Errata for 2018 Uniform Mechanical Code – 2nd Printing

The following are changes that we found after the second printing of the 2018 Uniform Mechanical Code. These changes may apply to your code book. Thank you.

FIGURE 802.8
EXIT TERMINALS OF MECHANICAL DRAFT AND DIRECT-VENT VENTING SYSTEMS
[NFPA 54: FIGURE A.12.9]

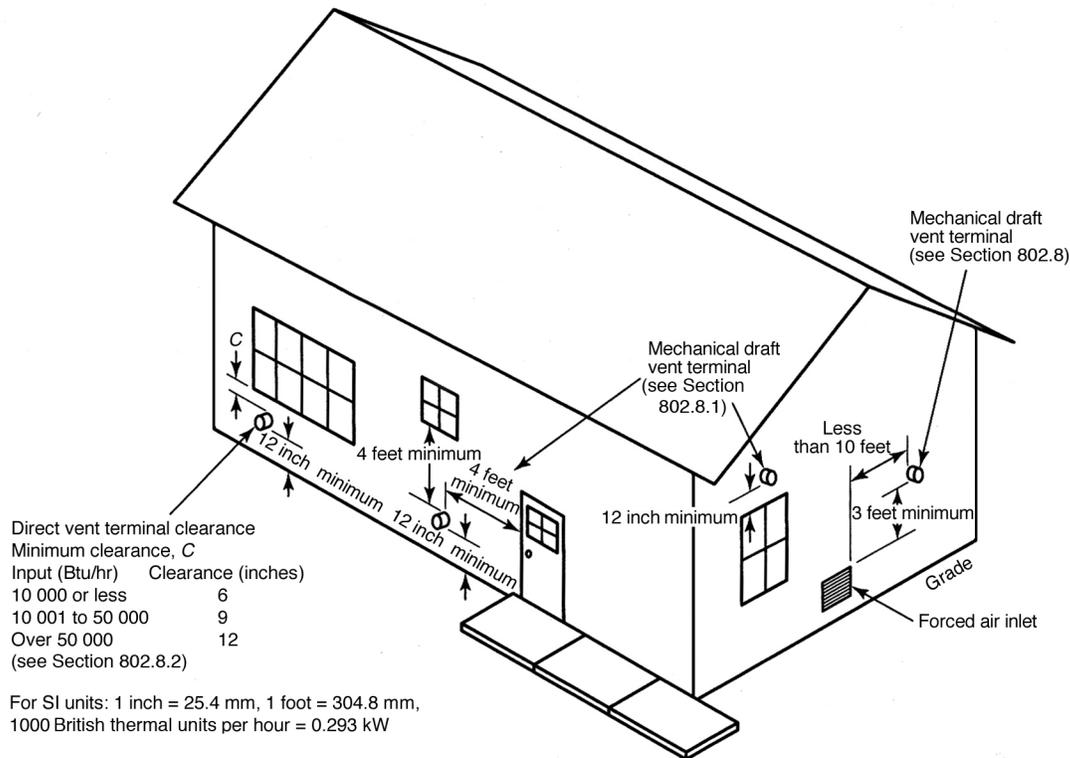
Figure 802.8 – Revise the following sections on the figure below: Section 509.8 to Section 802.8, Section 509.8.1 to Section 802.8.1 and Section 509.8.2 to Section 802.8.2.
